CITY PLAN COMMISSION

FILE NUMBER: S223-097

REQUEST: An application to create one 1.175-acre lot from a tract of land in City Block 5439 on property located on Arboreal Drive at West Northwest Highway / State Highway Loop 12, northeast corner.

PRELIMINARY PLAT
TOWN NORTH FELLOWSHIP NO. 2
LOT 1, BLOCK A/5439
 SHEET 1 OF 2
 1:50 ASSESSOR'S SCALE
 D. A. METROCK SURVEY, ABSTRACT NO. 997
 CITY OF DALLAS, DALLAS COUNTY, TEXAS
 ENGINEERING NUMBER D923-XXX
Gonzalez & Schneider State 500 Main Street, Suite 200
 2100 Lamar Boulevard, Suite 200
 DALLAS, TEXAS 75201
 Telephone: 972-311-4655
 Fax: 972-311-4655
 7/27/2023 11:48 AM

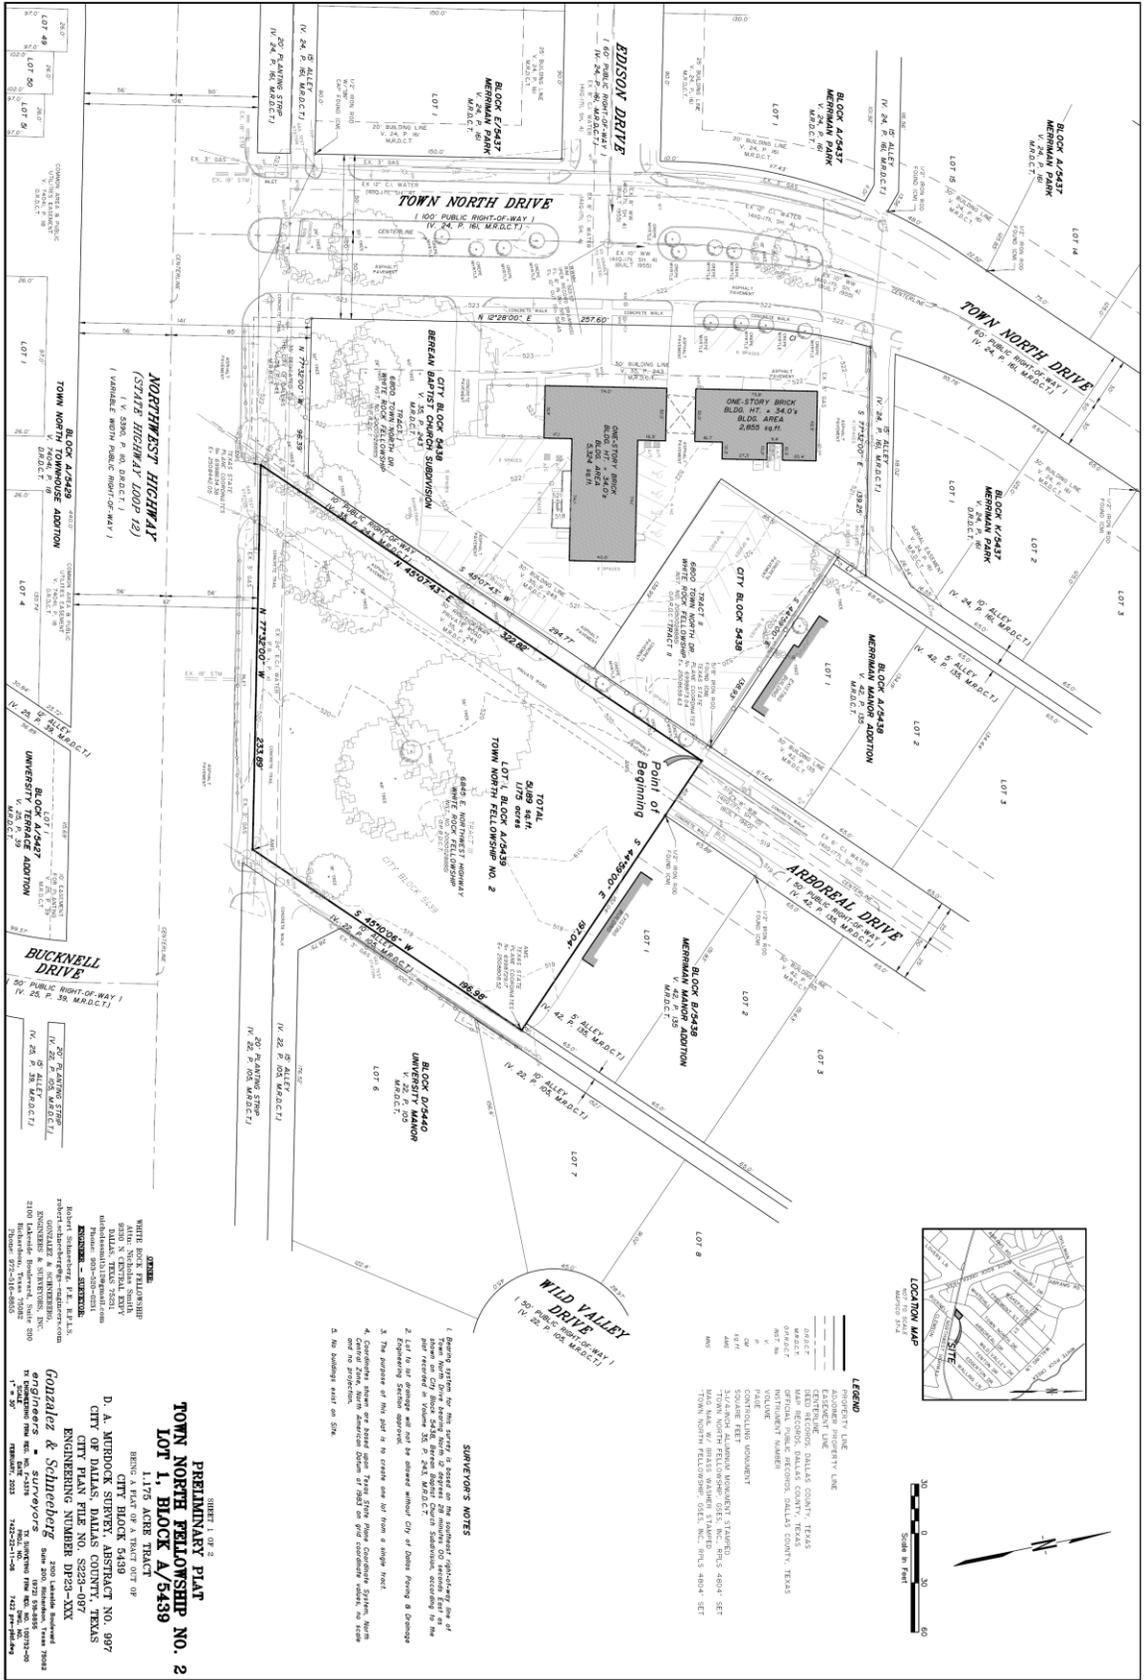
6. On the final plat, all easement abandonments, and ROW abandonments must be by separate instrument with the recording information shown on the face of the plat. A release from the Real Estate Division is required prior to the plat being submitted to the Chairman for signature.

7. On the final plat, include two boundary corners tagged with these coordinates: "Texas State Plane Coordinate System, North Central Zone, North American Datum of 1983 on Grid Coordinate values, No Scale and no Projection."

8. On the final plat, monument all set corners per the Monumentation Ordinance. Prior to submittal of the final plat for the Chairman's signature. The monuments must be verified by the Chief City Surveyors Office in the Public Works Department. *Section 51A-8.617*

11. The number of lots permitted by this plat is one.

15. On the final plat, dedicate 7.5 feet of right-of-way (via fee simple) from the established center line of the Alley. *Section 51A 8.602(c)*
16. On the final plat, dedicate 28 feet of right-of-way (via fee simple or street easement) from the established centerline of Arboreal Drive. Sections 51A-8.602(c), 51A-8.604(c) and 51A-8.611(c).
17. On the final plat, dedicate a minimum 10-foot by 10-foot corner clip (via fee simple or street easement) at the intersection of Northwest Highway / State Highway Loop 12 and Arboreal Drive. Section 51A 8.602(d)(1)

18. Prior to final plat, a larger corner clip may be requested during engineering plan and traffic review to accommodate an adequate turning radius, or to maintain public/traffic appurtenances, within the area of the corner clip. Section 51A 8.602(d)(1), 51A 8.608(a)
19. On the final plat, dedicate a 15-foot by 15-foot Alley Sight Easement at the intersection of Northwest Highway / State Highway Loop 12 & the alley. *Section 51A-8.602(e)*
20. On the final plat, add the note: "TxDOT approval may be required for any driveway modification or new access point(s)." No citation.

27. On the final plat, change "Northwest Highway (State Highway Loop 12)" to "Northwest Highway / State Highway Loop 12". Section 51A-8.403(a)(1)(A)(xii)
28. On the final plat, identify the property as Lot 1 in City Block A/5439. Ordinance 1A, Page 131 pages 131-148, Section 2 (passed August 13, 1872).
